Builder's Aggregate - M-1981-112

Re: Extension of Builders Aggregate, Inc. Substitute Water Supply Plan
WDID 0102764, SWSP ID 3147, Gravel Pit Permit No. M-81-112
NW1/4 Section 31, T4N, R57W, 6th P.M., Morgan County
Water Division 1, Water Districts 3 & 4

Re: Builders Aggregate, Inc. Substitute Water Supply Plan
WDID 0102764, SWSP ID 3147, Gravel Pit Permit No. M-81-112
NW1/4 Section 31, T4N, R57W, 6th P.M., Morgan County
Water Division 1, Water Districts 3 & 4

WELL PERMIT NUMBER 81256-F

Figure 1
Builder's Aggregate
General Location Map

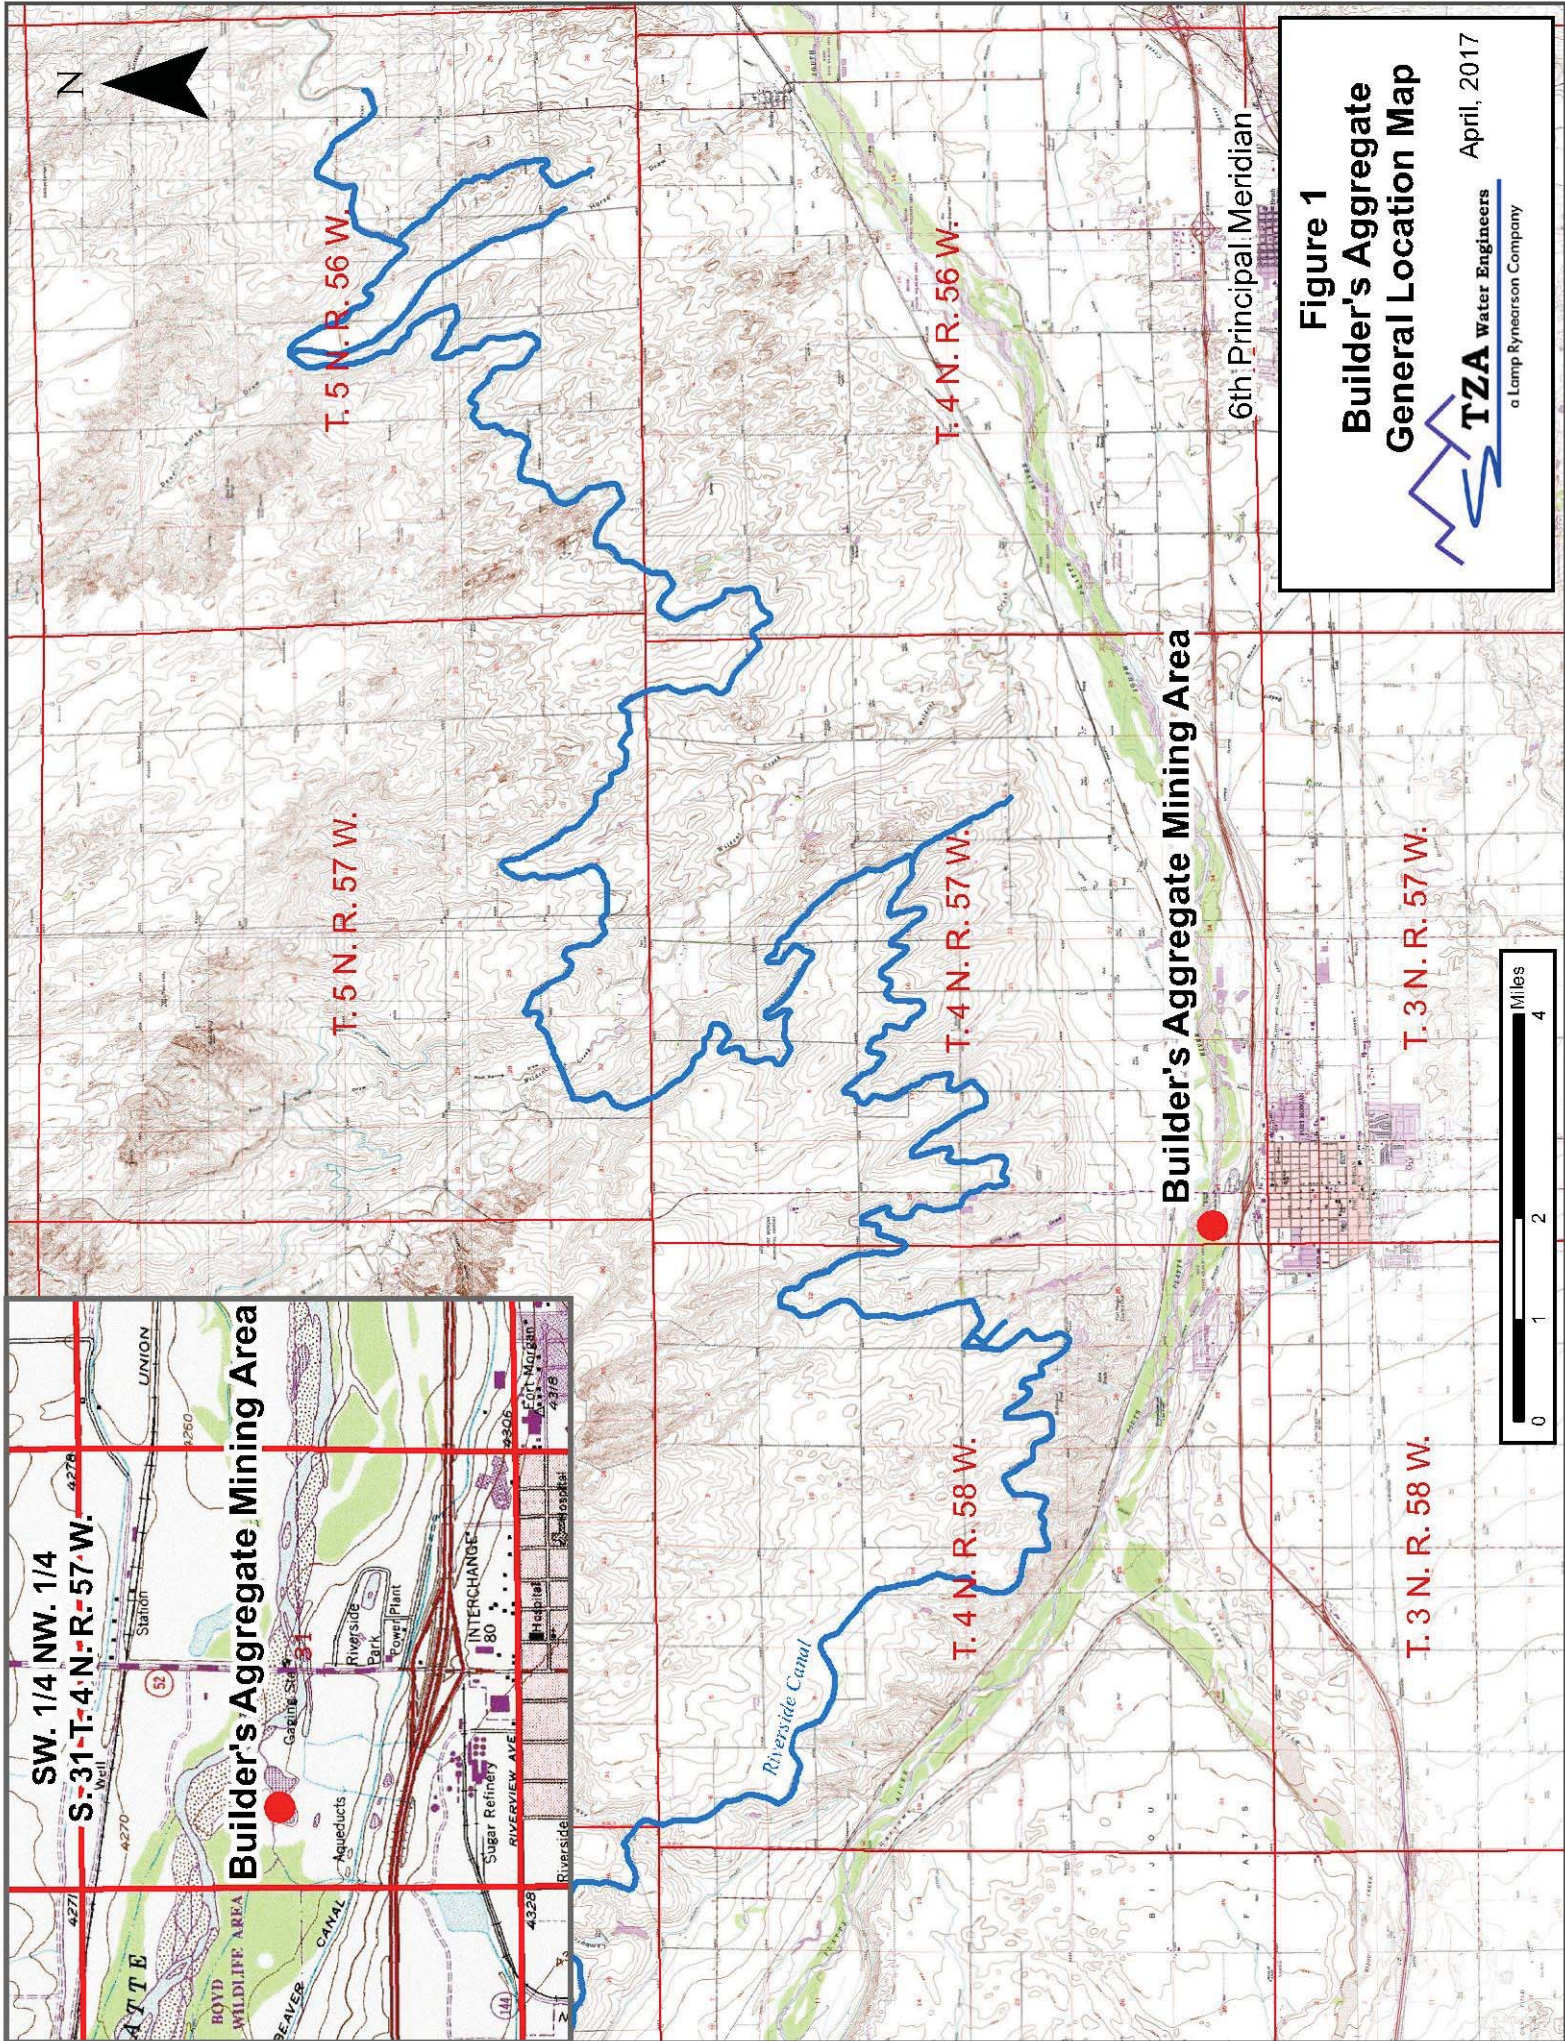
This SWSP submittal addresses the projected depletions from the BA Mine (0110923), located northwest of Fort Morgan on the south bank of the South Platte River in the NW1/4 of Section 31, T4N, R57W (see the attached Figures 1 & 2). BA uses a dredge to mine near the streambank, removing marketable materials and refilling parts of the pond with unmarketable aggregate. The area of exposed ground water will migrate as mining occurs on the property, but BA will maintain a maximum exposed surface area of 3.45 acres until the property is reclaimed. Although the mining pond has historically moved around within the mining boundary, and the bank separating the pond from the river was removed due to flooding in recent years, recent and historical aerial photos suggest that there has always been a surface water connection between the pond and the river, such that depletions to the river are instantaneous.

Figure 2
Approximate Location of
Mining Operation

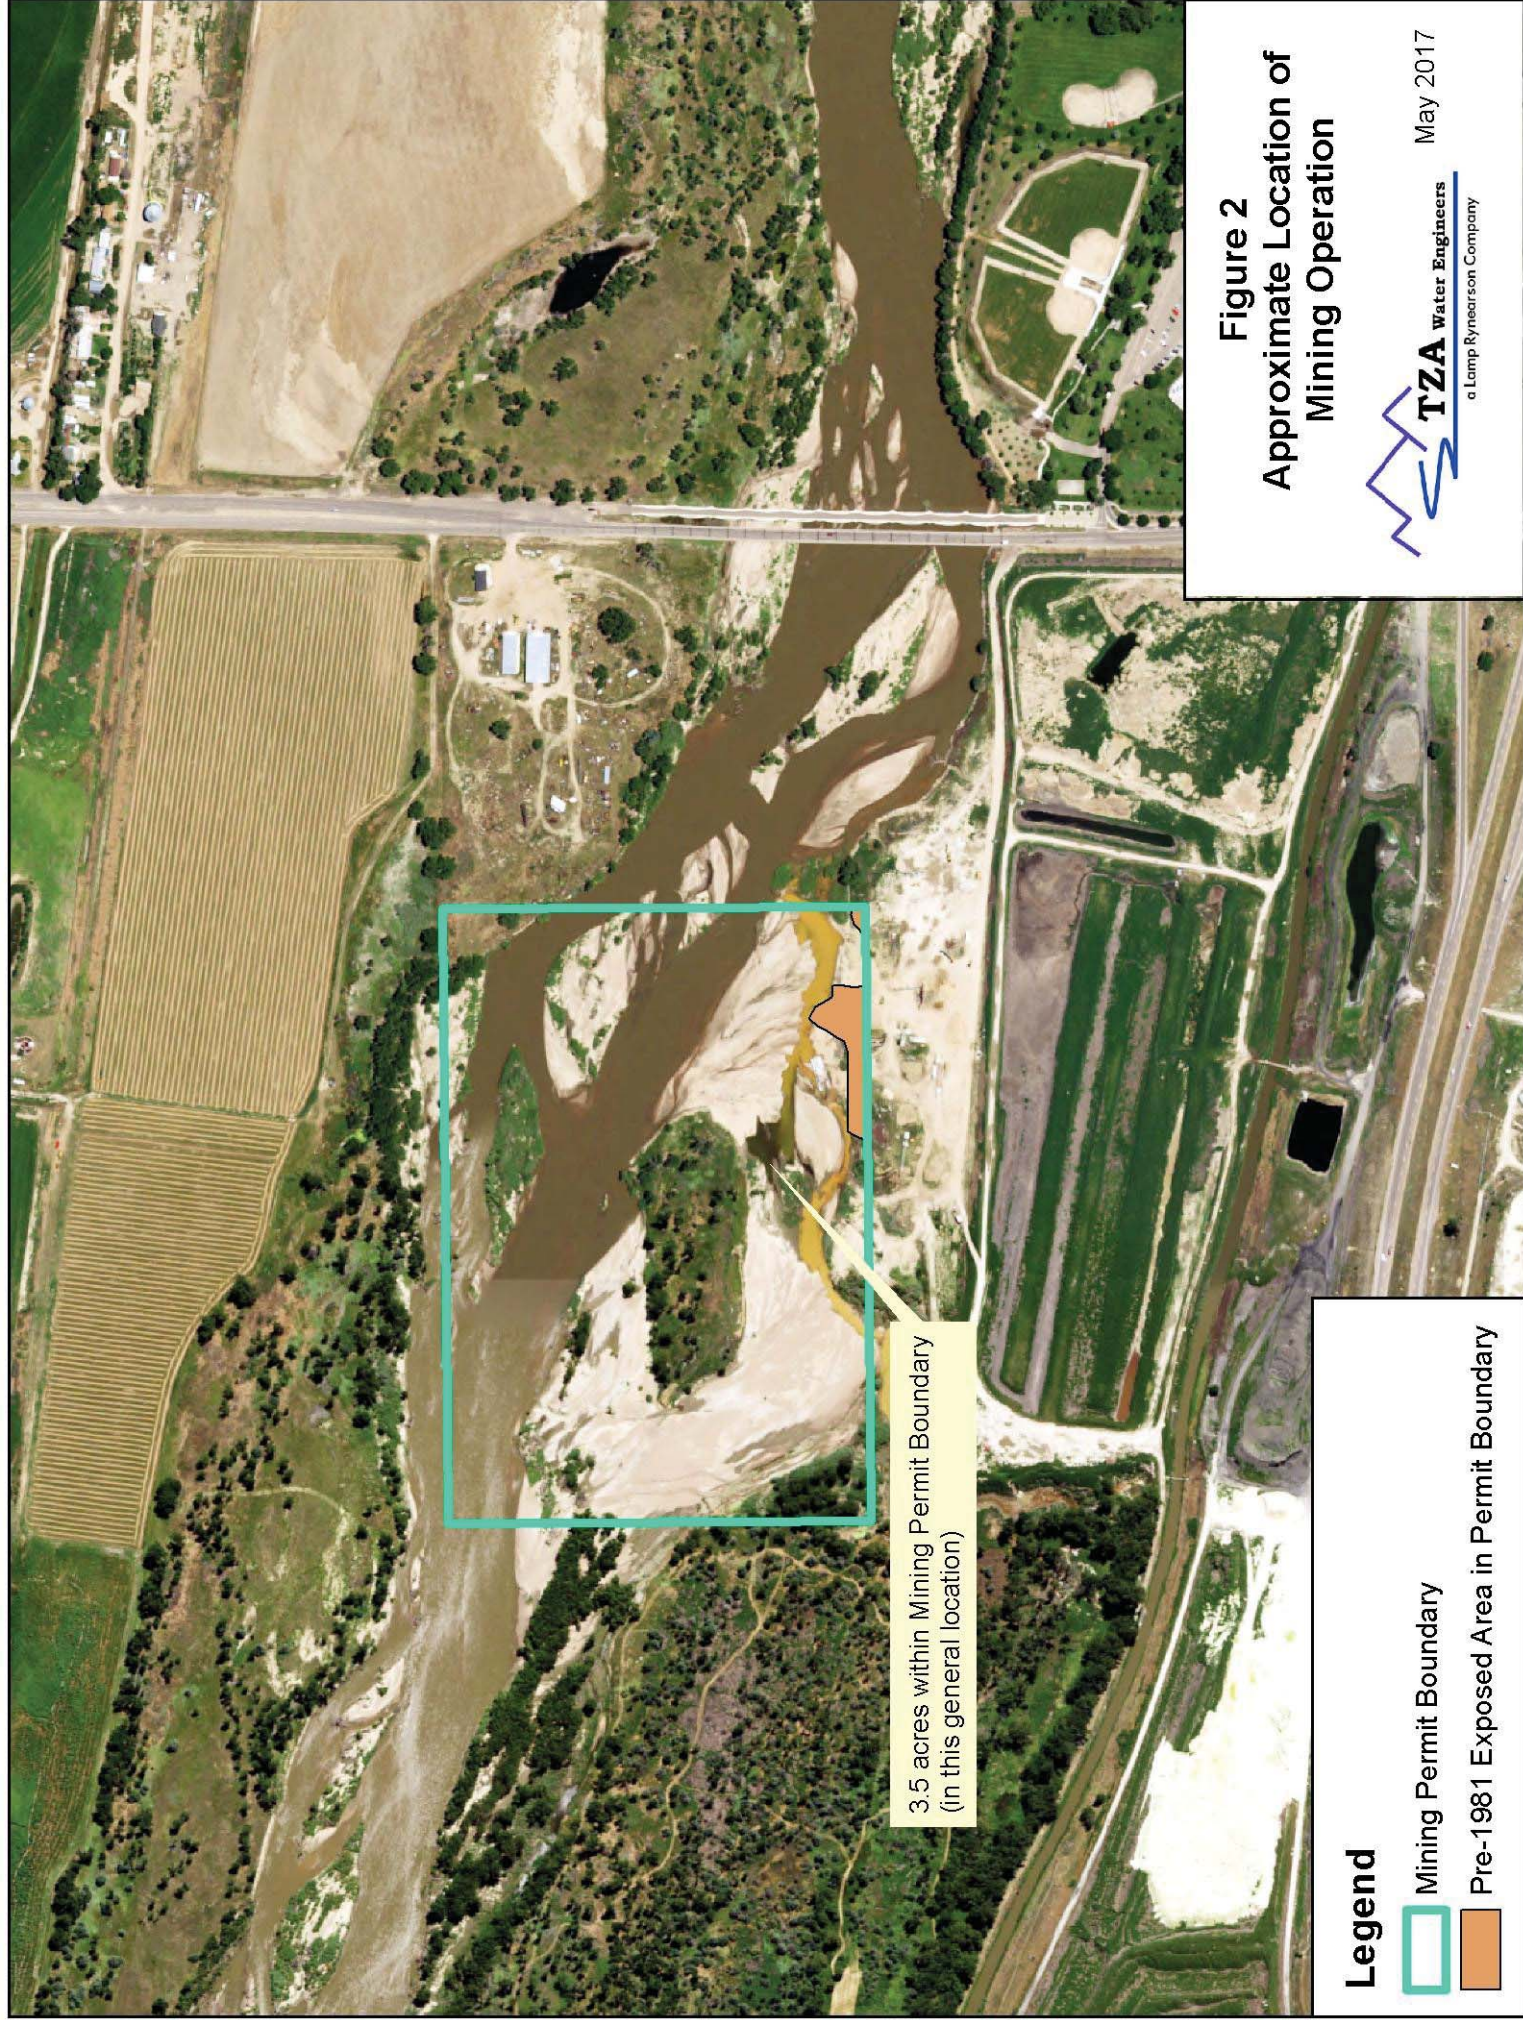
The Applicant described that a portion of the potential mined area was exposed to evaporation prior to 1981 and was naturally filled during flood events. The Applicant's Figure 2 shows the pre-1981 exposed area that is within the currently mining permit boundary. This area totals 0.76 acres, and it is not clear if any of this area is currently exposed to evaporation, since the stream channel has undergone a number of changes in recent years. Pursuant to Section 37-90-137(11)(b), C.R.S., a gravel pit operator does not need to replace depletions that occur due to evaporation from ground water exposed prior to January 1, 1981.

BA is not claiming the pre-1981 area to offset any of the planned exposed groundwater during this SWSP approval period. In order to claim the pre-1981 exemption in future years, the Applicant will need to comply with the requirements described in the Guidelines for SWSPs for Sand and Gravel Pits, including providing a pre-1981 aerial photo, a topographical map showing the pre-1981 area, and a shapefile of the area. DWR does not allow pre-1981 areas to be re-allocated to different locations within the permit boundary.
